Access Compliance Report Public Rights-of-Way (Curb Ramps)

Intersection ID: 45778	Main Street: CARVER FALLS RD	Cross Street: WINDING RIVER DR	Location: NE
ADA ID: 031A4034564C	Ramp Type: PerpDiag	Initial Pass/Fail: Fail	Overall Compliance: No
Severity Score: 10

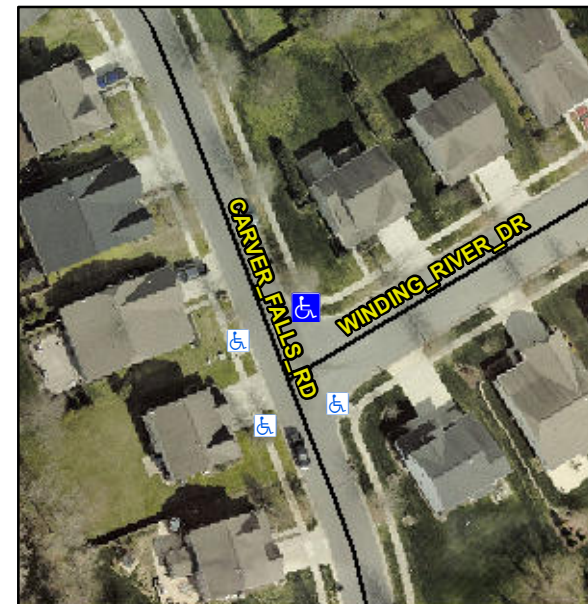
R304.5.1, R304.5.3

Compliance	Description	Data	Compliance	Description	Data
N/A	Ramp Length (in)	72.5	Yes	Ramp Slope (%)	6.0
No	Ramp Width (in)	47.0	No	Ramp XSlope (%)	3.3
N/A	Flare Type LT	N/A	N/A	Flare Type RT	N/A
N/A	Flare Slope LT (%)	N/A	N/A	Flare Slope RT (%)	N/A
N/A	Flare Traversable LT?	N/A	N/A	Flare Traversable RT?	N/A
N/A	Landing Length (in)	N/A	N/A	DWS Provided?	N/A
N/A	Landing Width (in)	N/A	N/A	DWS Contrast?	N/A
N/A	Landing Slope (%)	N/A	N/A	DWS Length (in)	N/A
N/A	Landing X Slope (%)	N/A	N/A	DWS Full Width?	N/A
N/A	Landing Curb? (Y/N)	N/A	N/A	DWS Offset (in)	N/A
N/A	Shared Landing?	N/A			
N/A	Gutter Ponding?	N/A	N/A	Gutter Slope (%)	N/A
N/A	Gutter Lip Ht (in)	N/A	N/A	Gutter X Slope (%)	N/A
N/A	Painted X Walk1?	No	N/A	Painted X Walk2?	No
	X Walk 1 Direction	To W		X Walk 2 Direction	To S
N/A	X Walk 1 Width (in)	N/A	N/A	X Walk 2 Width (in)	N/A
	X Walk 1 Slope (%)	0.6		X Walk 2 Slope (%)	0.8
	X Walk 1 X Slope (%)	0.6		X Walk 2 X Slope (%)	1.9

Remove & Replace Curb Ramp With Two New Directional Ramps or Equivalent.
